From: Peter Daly
Sent: 01 December 2021 13:16
To: Ian Leary
Cc: Dennis Parbhu
Subject: 114 Adelaide Road - follow-up from yesterday's meeting
Attachments: Floor Plan Sketches.pdf; Floor Plan Overlays.pdf

SR490717
TRAMWAY HOTEL
GROUND FLOOR

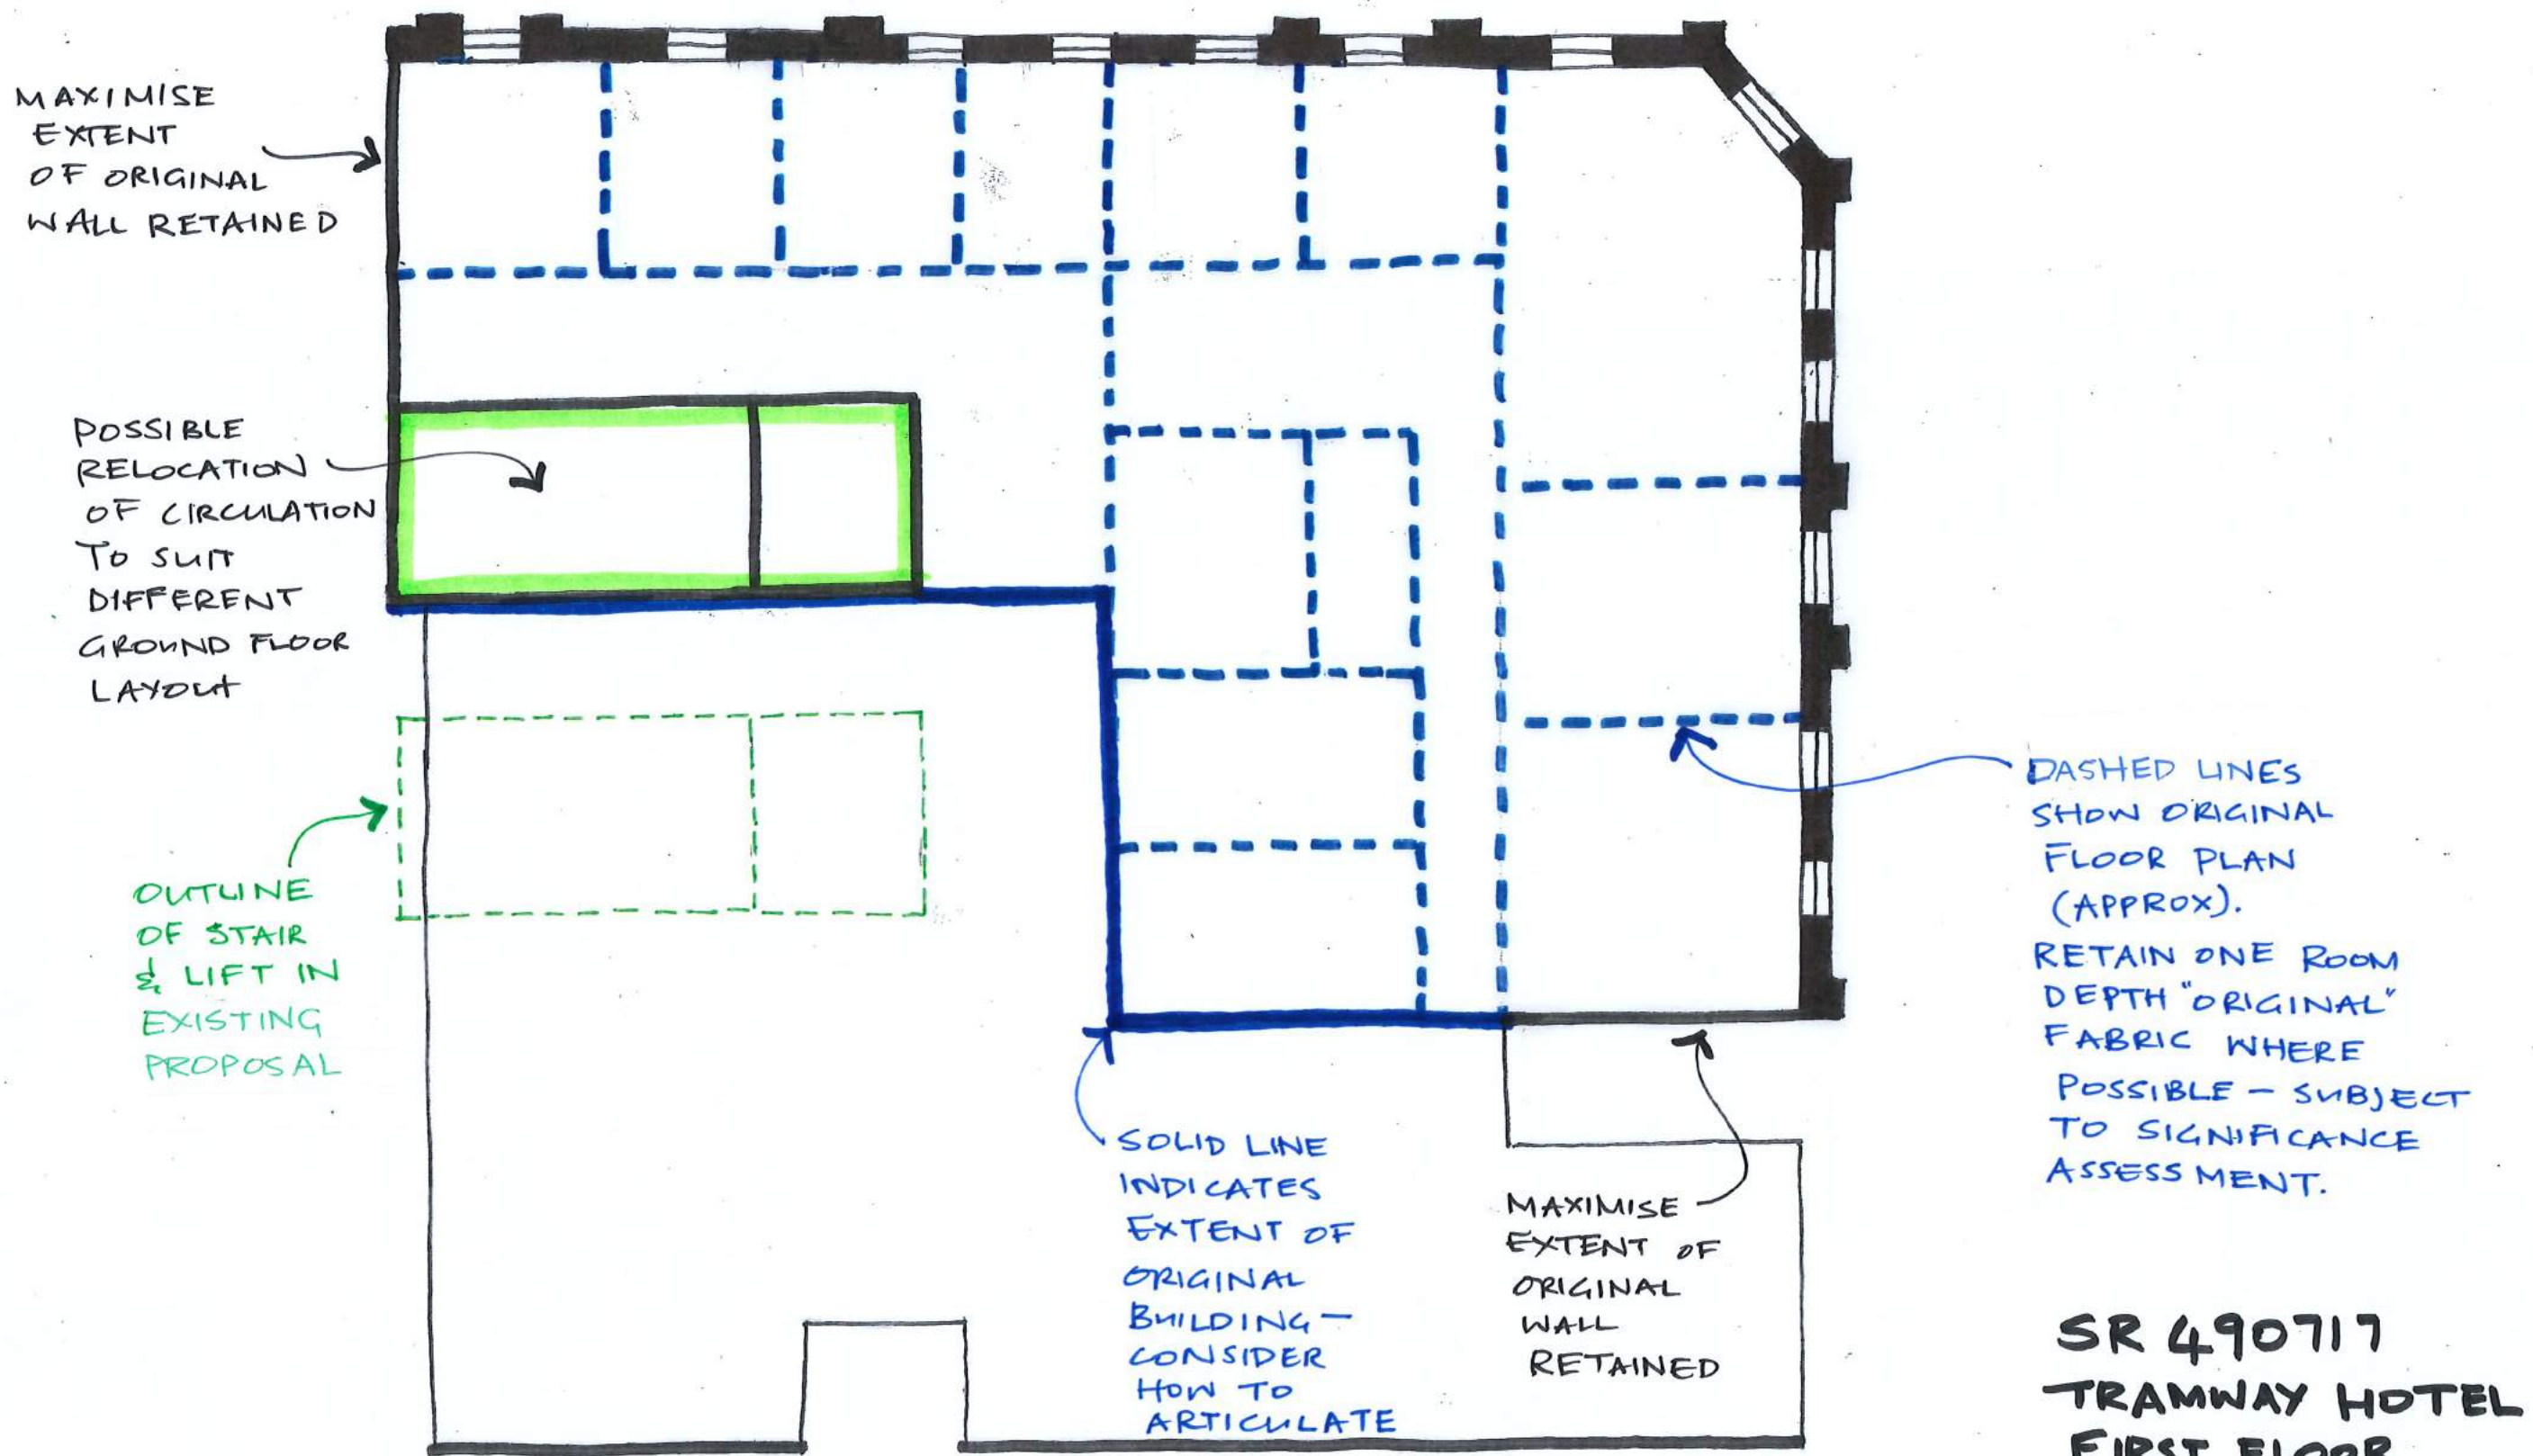
POSSIBLE
RELOCATION
OF CIRCULATION
TO SUIT
NEW VEHICLE
MOVEMENT &
RETAIN EXT.
BUILDING LINES

OUTLINE OF
STAIR & LIFT
IN EXISTING
PROPOSAL

REPOSITION
TURNING
CIRCLE &
CAR LIFT
(IF REQ'D)
TO RETAIN
EXTERIOR
BUILDING
LINES

DASHED LINES
SHOW ORIGINAL
FLOOR PLAN
(APPROX.).

RETAIN ONE
ROOM DEPTH
"ORIGINAL" FABRIC
WHERE POSSIBLE -
SUBJECT TO
SIGNIFICANCE
ASSESSMENT

MAXIMISE EXTENT
OF ORIGINAL WALL
RETAINED
